Preferred Project Report (Revised) for

Major Project Application No. MP09-0166 for Altitude Aspire, Terranora

Submitted to
Newland Developers Pty Ltd
April 2013

Title:	Revised Preferred Project Report
Author(s):	B. Lees and D. Holstein
Status:	Issue 1 – Revised PPR
Client:	Newland Developers Pty Ltd
Application No:	09_0166
Synopsis:	This Preferred Project Report (PPR) addresses the issues the Department of Planning (DoP) and Tweed Shire Council (TSC) have identified as requiring resolution, confirmation and/or clarification from the original Preferred Project Report (PPR) for a proposed development designated as 'Altitude Aspire' which forms part of the overall proposed development of land identified in TSC's Residential Development Strategy as 'Area E', located at Terranora NSW. The submissions made to the DoP during exhibition of the Environmental Assessment (EA) of the proposed 'Altitude Aspire' development with consideration to TSC Development Control Plan DCP B24, and the engineering criteria listed in A5 of the Tweed DCP have been specifically addressed within the report. The Revised PPR continues to establish the basis on which the development may be serviced with the rel

SK 3645
REVISION B

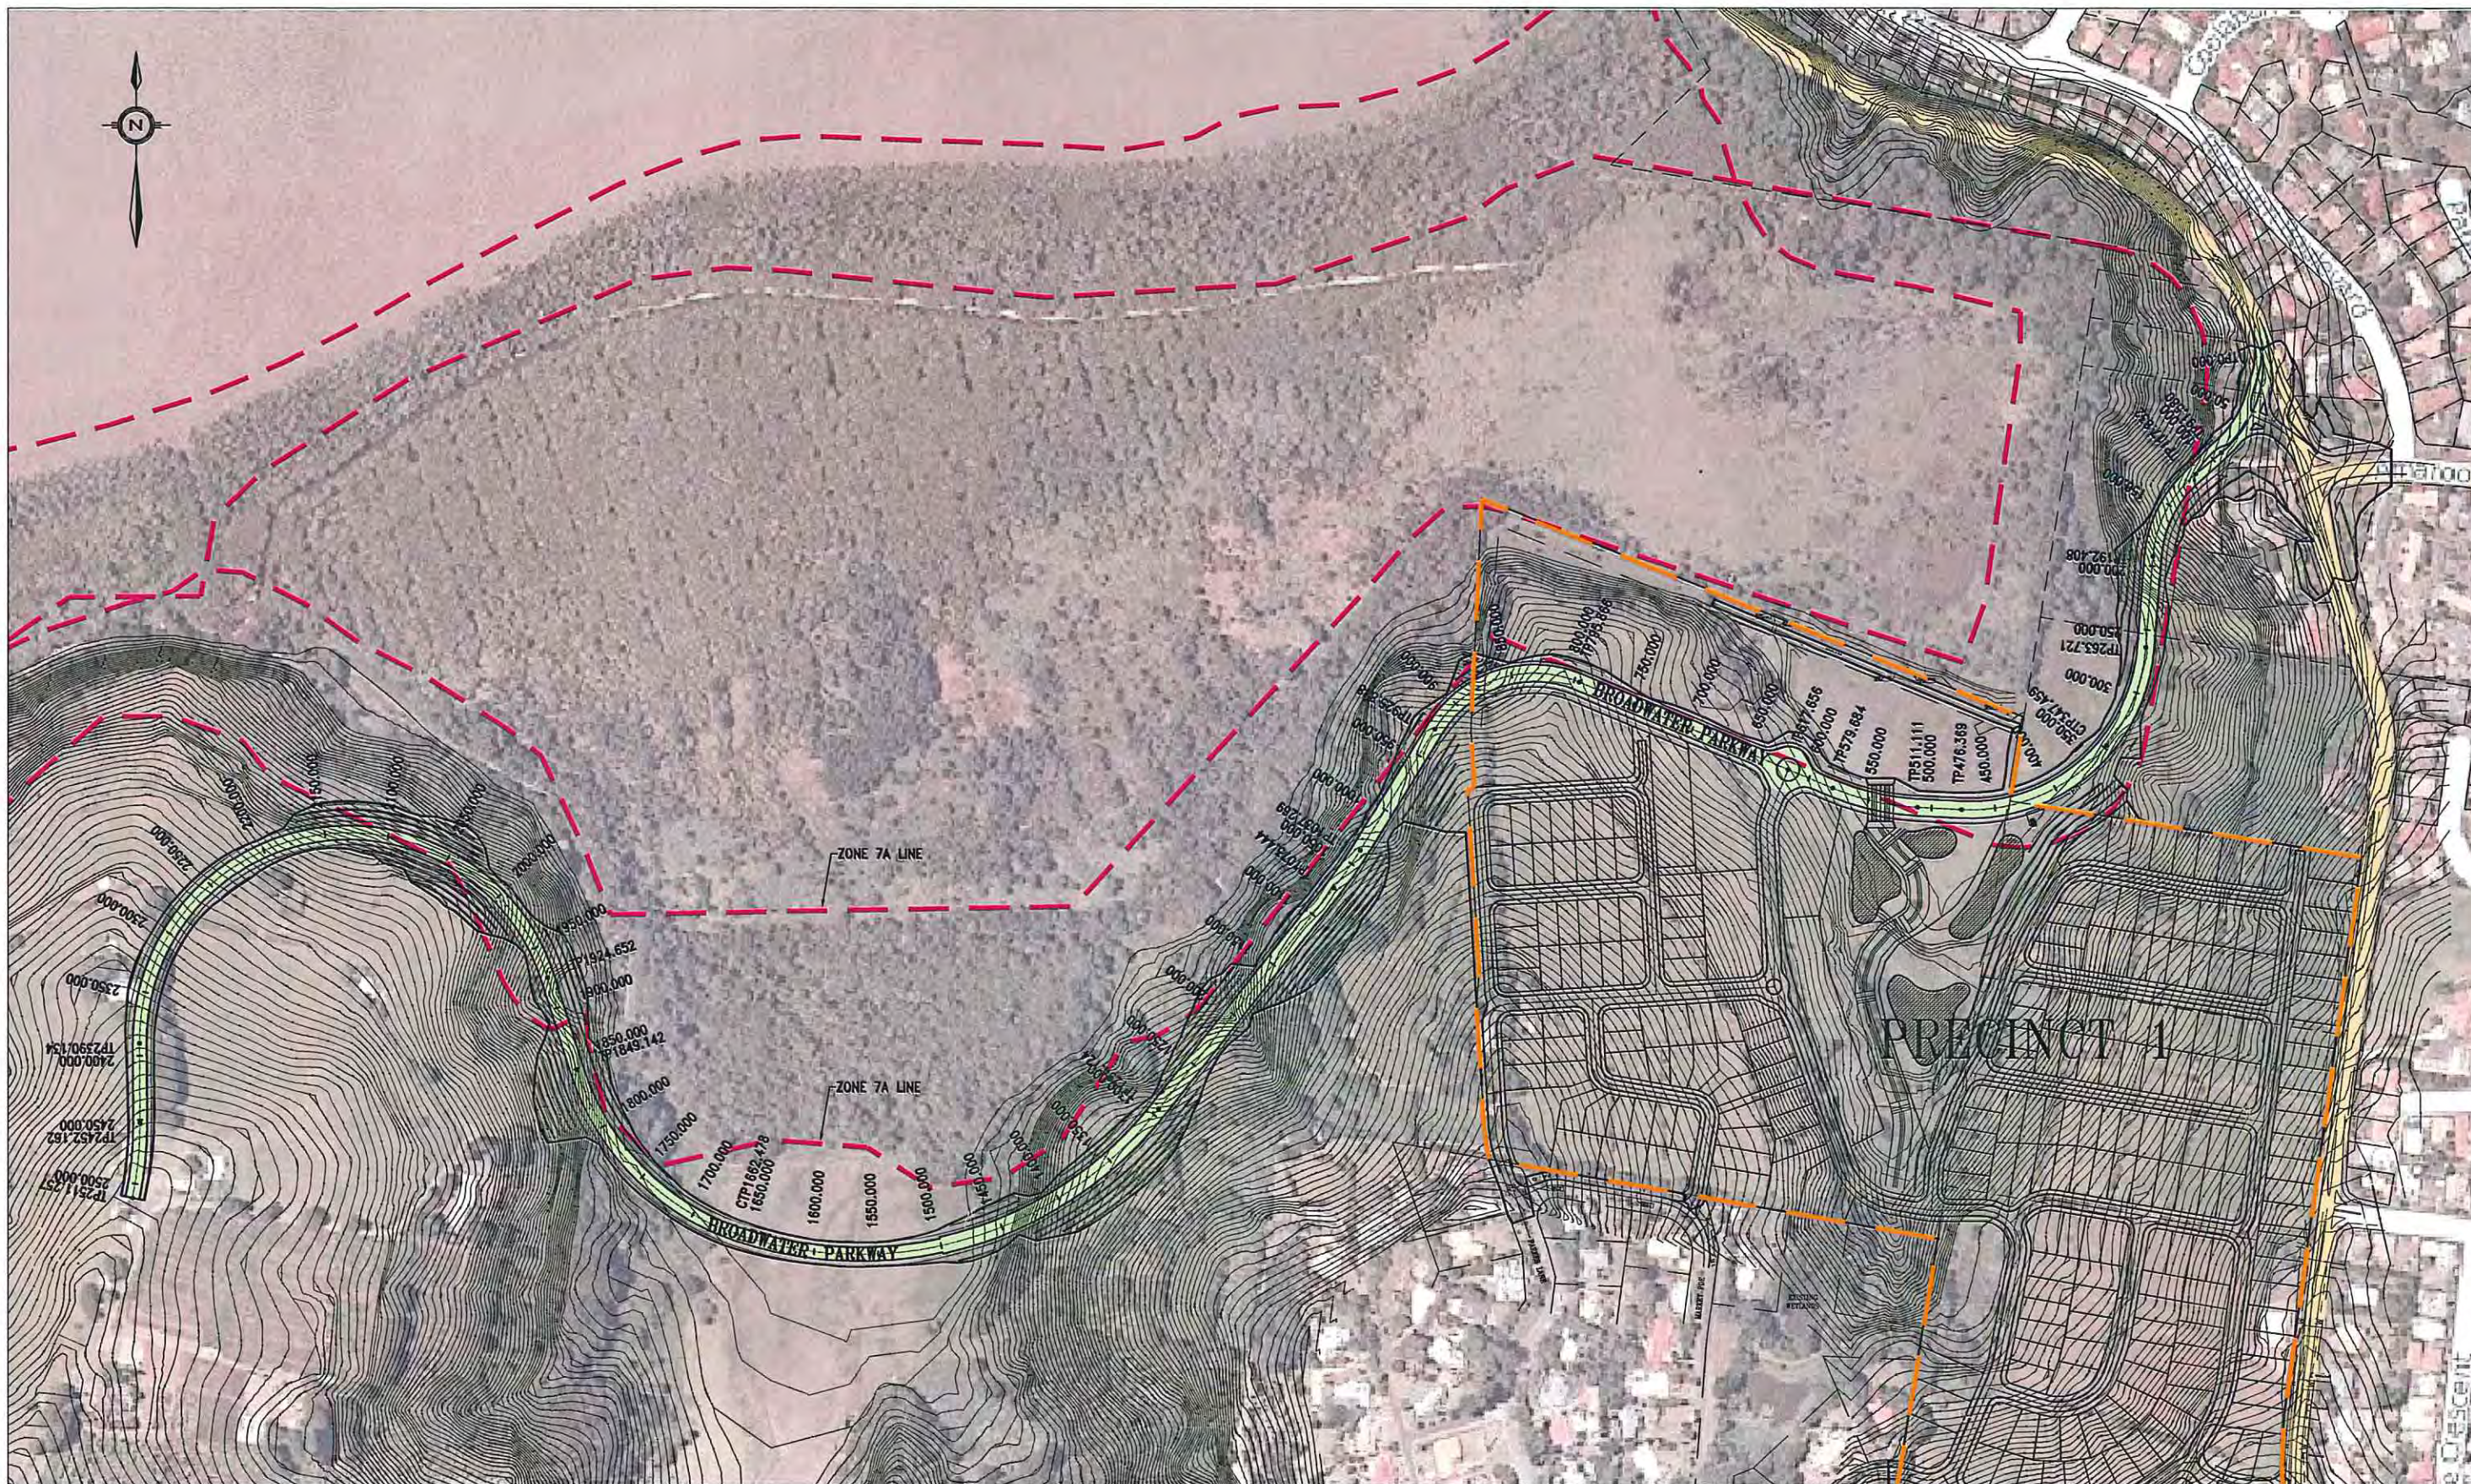
Project Element	Agency	Submission Item	Response	Reference in this report
Broadwater Parkway	DoP	Road alignment inconsistent with LEP. The alignment shown in DCP Section B24 is the preferred alignment.	Concept alignment complies with TSC DCP Section B24	Appendix 3- Road Hierarchy Plan
		Alignment must be consistent with whole of Area E.		
		Justification of preferred route is required.		
		Layout design must consider this road may never be constructed (due to local area contributions and land acquisitions).	Addressed with road hierarchy and development staging.	Appendix 1 & 3 Also refer to details within Bitzio's Consulting's (Traffic Engineers) Revised Transport for Preferred Project Report (PPR)
	Department of Climate Change and Water	A 50m vegetated buffer free of all infrastructure is recommended to protect the SEPP14 Wetland, Freshwater Wetland and Floodplain Rainforest EEC from modification and stormwater runoff.	Concept alignment provides 50m buffer as shown on Aerial Photo and Broadwater Parkway Proposed Alignment	Appendix 1 & 3
